TECHNICAL BULLETIN

UPS0512-4bNAS1

SECTION: 417**Update Prior to Sale: Right-Hand Rear Fog Lamp****AFFECTED VEHICLE RANGE:****XK (X150)****VIN: Specific vehicles; see attached list
Model Year: 2012****CONDITION SUMMARY:**

Situation: A limited number of 2012 model year Jaguar XK vehicles may have been manufactured away from process and in some cases the right-hand (RH) rear fog lamp may be incorrectly welded.

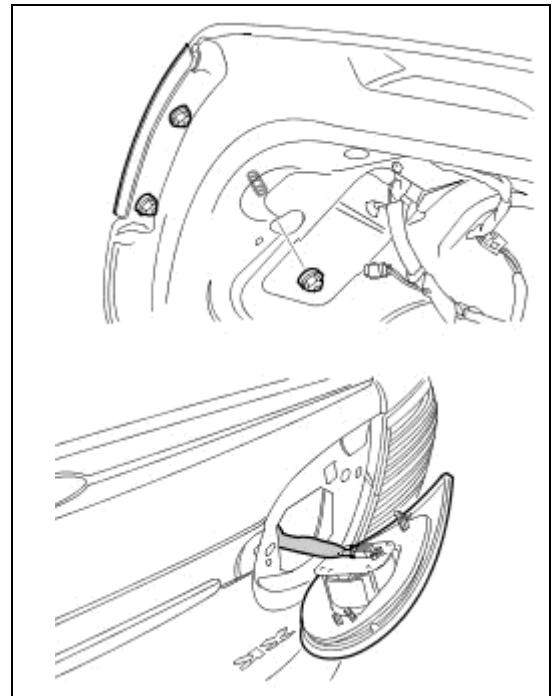
⚠ CAUTION: Clean the contact areas on the lamp making sure all grease and dirt is removed before installing the foam surround.

4. Fit foam seal surround to **new** RH reverse / fog lamp:
 - Starting at the top of the new lamp, peel back the protection and apply foam surround to lamp.
 - Cut off and discard any excess seal.
